5. Bridge Creek Coop Subdivision 2024 Replat; KPB File 2024-133 Seabright Survey & Design / Farmwald, City of Homer Location: Arnold Avenue & Mae Street Diamond Ridge Area

ITEM 5 - PRELIMINARY PLAT Bridge Creek Coop. Subdivision 2024 Replat

KPB File No.	2024-133
Plat Committee Meeting:	January 13, 2025
Applicant / Owner:	Jay A. Farmwald and Rita R. Norton of Anchorage, Alaska, and The City of Homer
Surveyor:	Katherine Kirsis – Seabright Survey and Design, LLC
General Location:	Diamond Ridge
Parent Parcel No.:	173-700-04; 173-700-05; 173-700-06; 173-700-07; 173-700-08; 173-700-09;
	173-700-10
Legal Description:	Township 6 South, Range 13 West, Section 4, Seward Meridian, HM 81-05,
	Bridge Creek Cooperative Subdivision Lots 1, 2, 3, 5,6,7, and HM 88-054, Bridge
	Creek Cooperative Subdivision No 2, Lot 4A
Assessing Use:	Residential Vacant, Residential Accessory Building and Residential Improved
	Land
Zoning:	Bridge Creek Watershed Protection District
Water / Wastewater	On-Site – On-Site
Exception Request	None Requested

Staff Report 24-056

KPB 2024-133

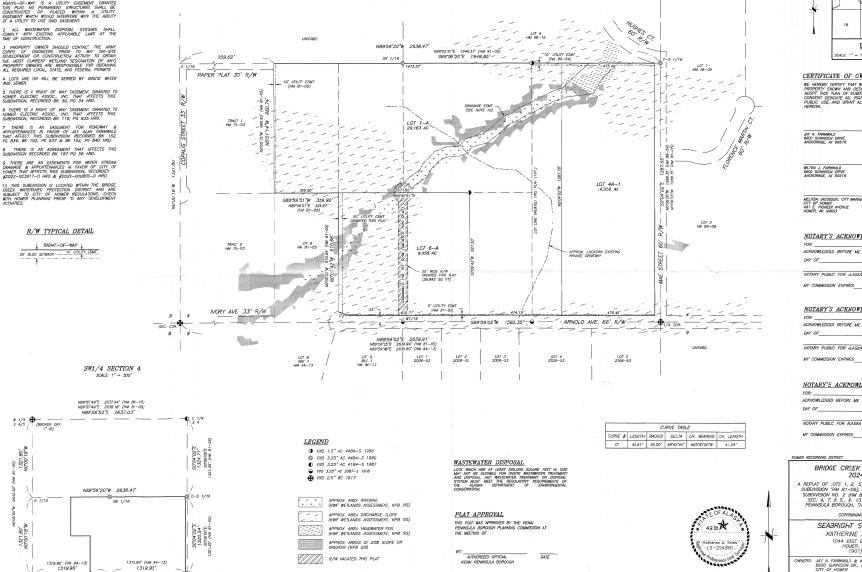
An agreement listed on the CTP is noted on the plat as plat note number eight. Staff has determined that plats Tall Country Estates, HM 88-15 and Bridge Creek Cooperative Subdivision No. 2, HM 88-54, have resolved this agreement. Therefore, *staff recommends* that plat note number eight can be removed.

There is steep terrain shown on the plat with grades over 25% shaded on the drawing. **Staff recommends** the shading remain for the final submittal and the contours be removed. Add arrows to show the direction of slope.

There are water stream drainage easements and appurtenances recorded in the Homer Recording District, serial numbers 2022-003917-0 and 2023-000803-0, affecting the subdivision. The easements are noted as plat note number nine and depicted on the plat. *Staff recommends* that the depiction note be modified to reflect note number nine.

A right-of-way easement was granted to Homer Electric Association, Inc., recorded in Book 119, Page 935, to construct, operate and maintain an electric transmission and/or telephone distribution line or system located on the north ten feet of former Lot 4, Bridge Creek Cooperative Subdivision, HM 81-5. This easement is noted on the plat as plat note number six. *Staff recommends* the utility easement depicted on proposed Lot 4-A should reference plat note number six.

The parent plat, Bridge Creek Cooperative Subdivision No. 2, HM 88-54, depicts a 10-foot utility easement along the north lot line of former Lot 4A. The plat shows a five-foot utility easement along the north and south of the north lot line. *Staff recommends* that the surveyor depict and label the easement to reflect the parent plat.

- Modify the plat approval note with the meeting date, January 13, 2025.
- Modify the KPB file number to 2024-133 to the title block.
- Modify Arnold Avenue to be a 33-foot right-of-way.

Modify name of subdivision to reflect spelling of parent plat, "Bridge Creek <u>Cooperative</u> Subdivision 2024 Replat" and reference to the parent subdivisions in the legal description should reflect the same.

Depict and label section line easements to the south and west. Modify street name to, "Paper Plat Avenue." Correct width of Arnold Avenue to 33 feet as no plat dedicated 33' from the south

Label roads to proposed plat location

- 3. ROW Vacation Diagram
- 4. Diagram indicating requested plat changes
- 5. Public Notice
- 6. Aerial Map

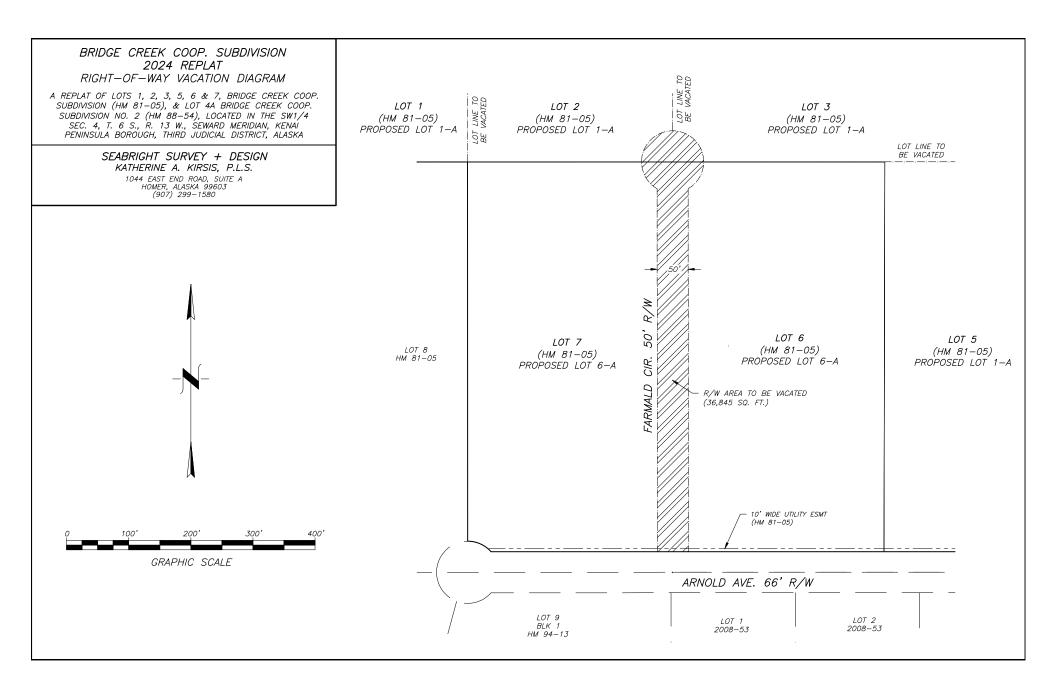
- 1. The spelling of "Farmald Cir. 50' R/W" on both the preliminary plat and the right-of-way vacation diagram be corrected to "Farmwald Cir. 50' R/W."
- 2. The addition of a Plat note: All lots are located within the Bridge Creek Water Shed Protection District and are subject to City of Homer Regulations. Check with Homer Planning Prior to any development activities.
